1 Proposed Winter Sporting Facility at 2 Tench Avenue, Jamisontown

The purpose of this report is to present the outcomes of a recent public exhibition of a Planning Proposal, draft Development Control Plan (DCP) and Voluntary Planning Agreement (VPA) offer prepared in support of a proposed Winter Sporting Facility at 2 Tench Avenue, Jamisontown, and to obtain Council's decision in respect to the proposal.

Figure E13.15 Shadow diagrams generated by the indicative building envelope showing maximum extent of shadow

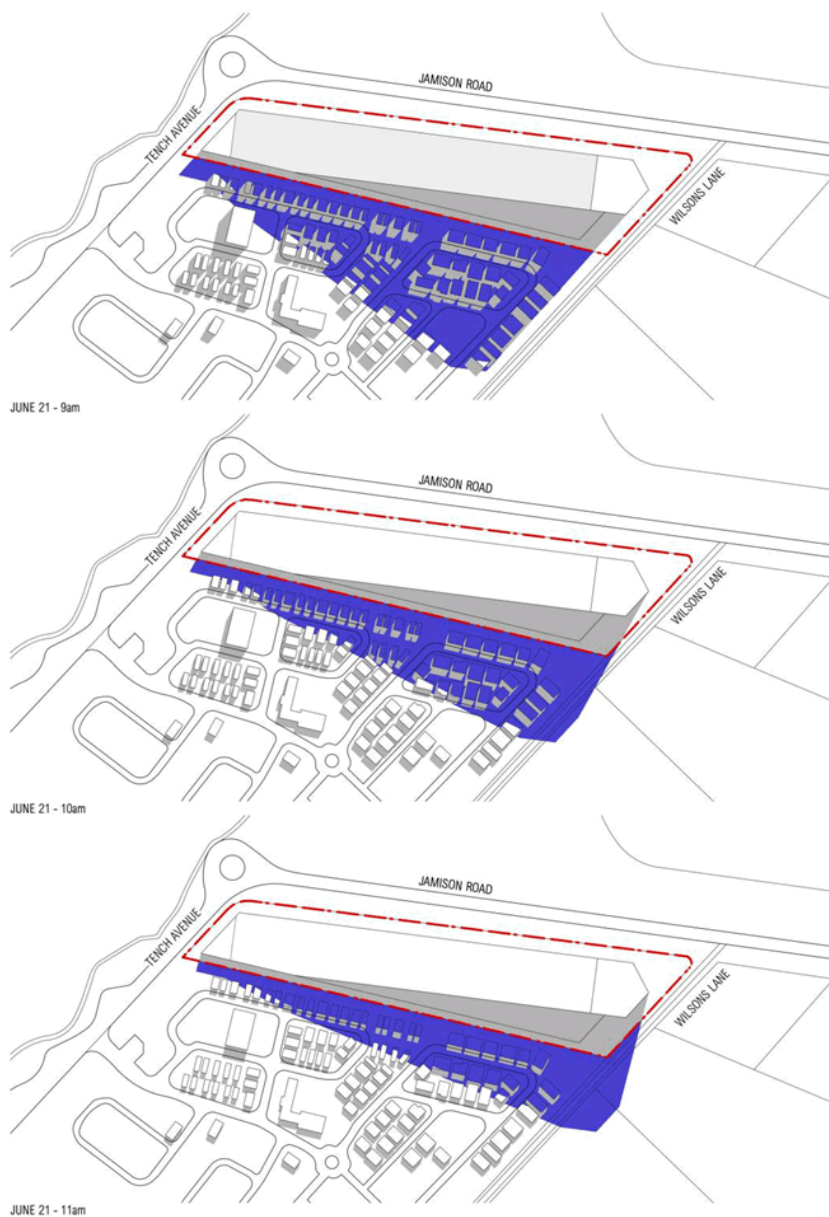
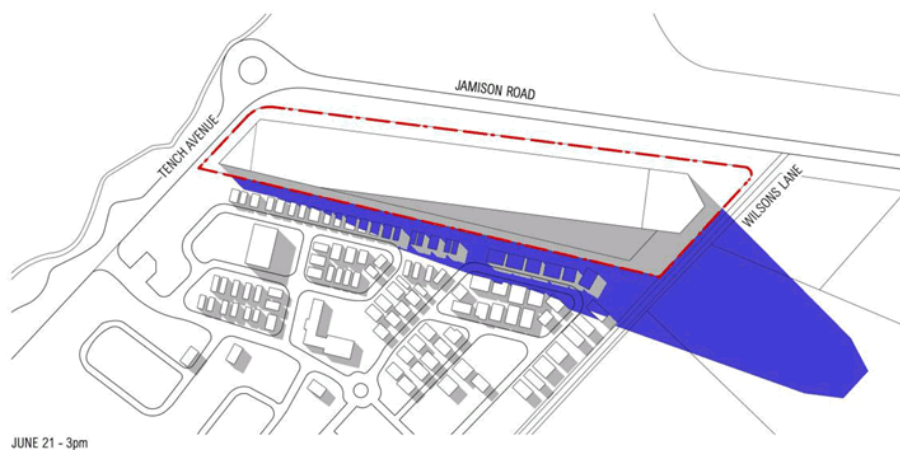
The documentation supporting the Planning Proposal, namely the draft DCP, as well as indicative building envelope plans provided by the proponent, indicates that large parts of Nepean Shores will be overshadowed in mid-Winter between 9am and 3pm. This is particularly applicable to the dwellings on the northern boundary of Nepean Shores, which will be overshadowed all day in mid-Winter. Many of these affected dwellings contain long-term residents.

Given that the dwellings along the northern side of Nepean Shores will be overshadowed all day in mid-winter, and many of these dwellings are long term residents, council officers recently requested the proponent to provide a response in respect to concerns over the impact of solar access to Nepean Shores.

Council officers have undertaken a significant amount of analysis in regards to the impacts on solar access to Nepean Shores, and have enabled the proponent to provide a submission as part of this process. Significant concern has been identified in respect to the impacts on solar access from the proposed development.
